**HSCC (INDIA) LIMITED**  
(A Subsidiary of NBCC (India) Limited)  
(A GOVERNMENT OF INDIA ENTERPRISE)

**AMENDMENT No.- II**

**Project Name:** Tender for “Construction of Hospital and Allied Buildings for AIIMS Rajkot and their Maintenance during Defect Liability Period on Design, Engineering, Procurement and Construction (EPC) basis”

**A. Reply to Pre Bid Queries raised by bidders during pre -bid meeting held on 06.01.2020 at HSCC, Head Office, Noida**

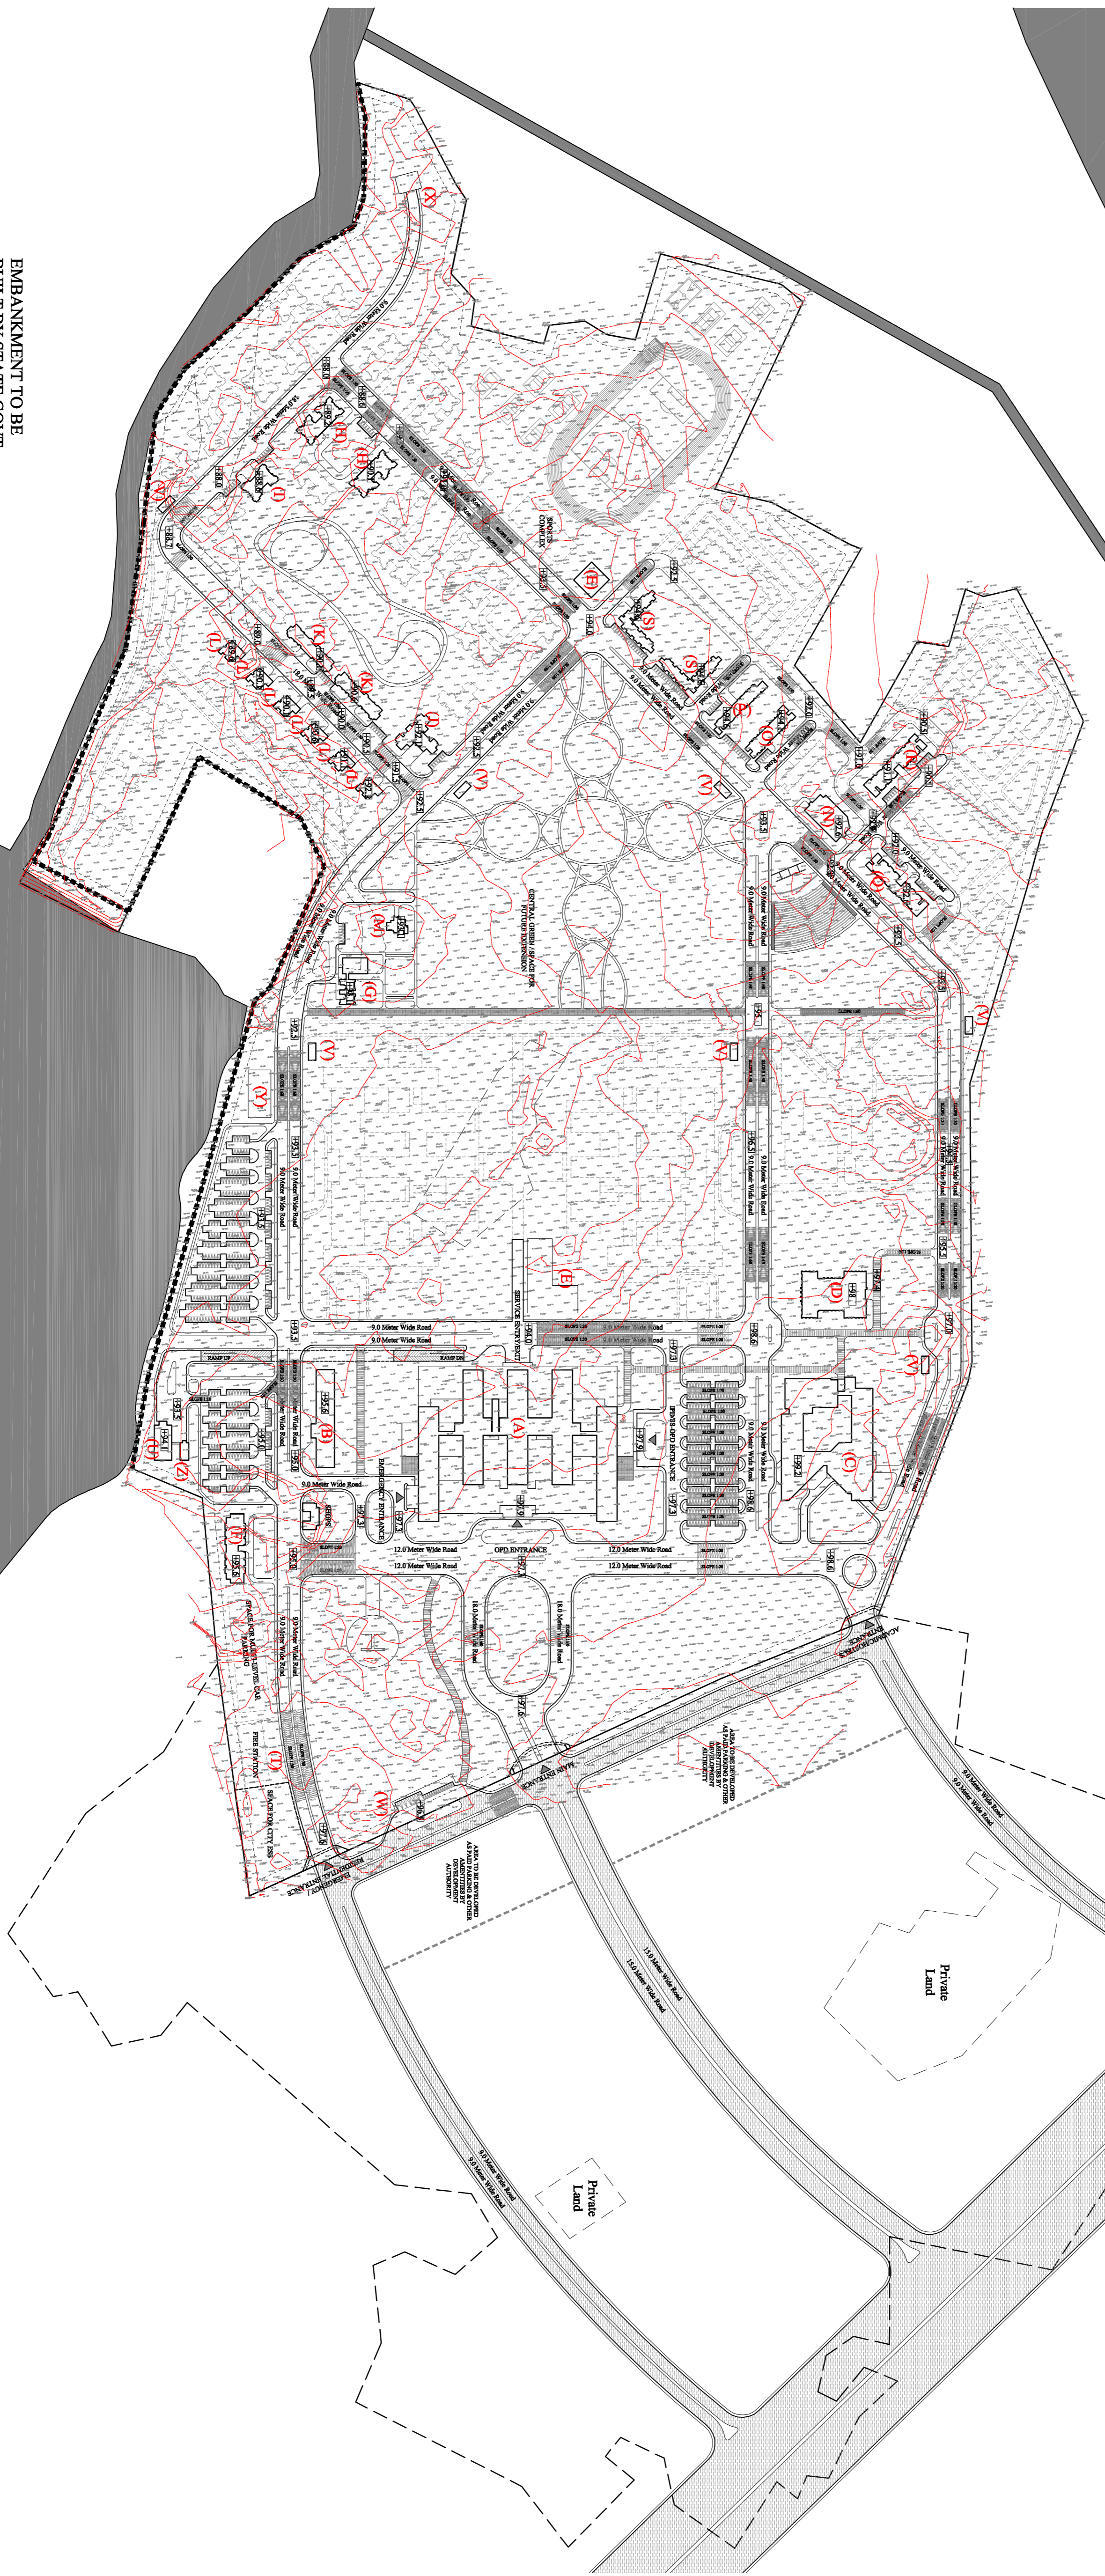
14.	Technical point			Drawing No A survey-02 site plan with survey line shows service block 'E' at two location with rectangle building footprint , whereas drawing no A-01 site layout plan shows service block 'C' at one location with 'C' shape building footprint. Please clarify scope of work for service block.	Drawing No.A, Survey -02 Site Plan (revised) enclosed. For Service Block Plan refer reply under Sl.No.15
